Connections to AM4372

AM4372 datasheet recommendation

board schematic nets

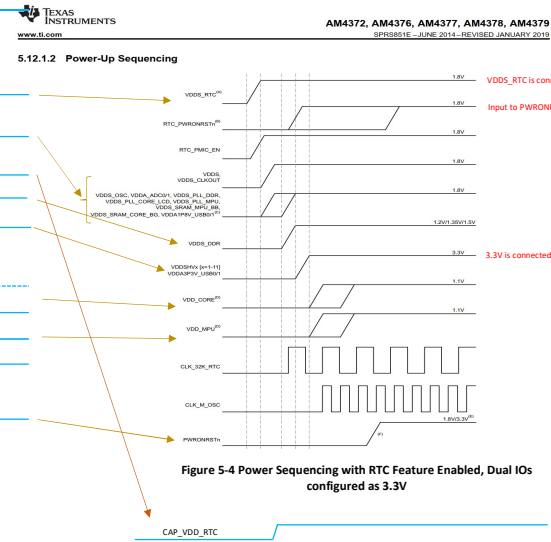
VDD5_RTC is connected to RTC_KALDO_ENn in the board
 Input to PWRONRSTn is level shifted and connected to RTC_PWRONRSTn in the board

3.3V is connected to VDD53P3V_IOLDO in the board

waveforms observed in board
(1ms/div)

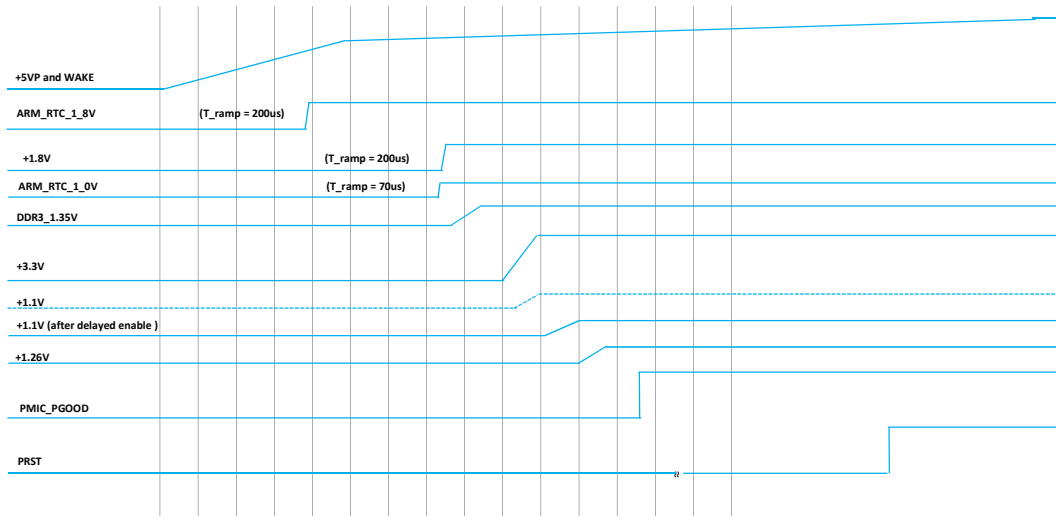
Initially observed that 1.1V is rising along with 3.3V. (Is it a problem ?)
 Hence we added delay in enable of 1.1V so that the output starts rising only after 3.3V settles to final value.
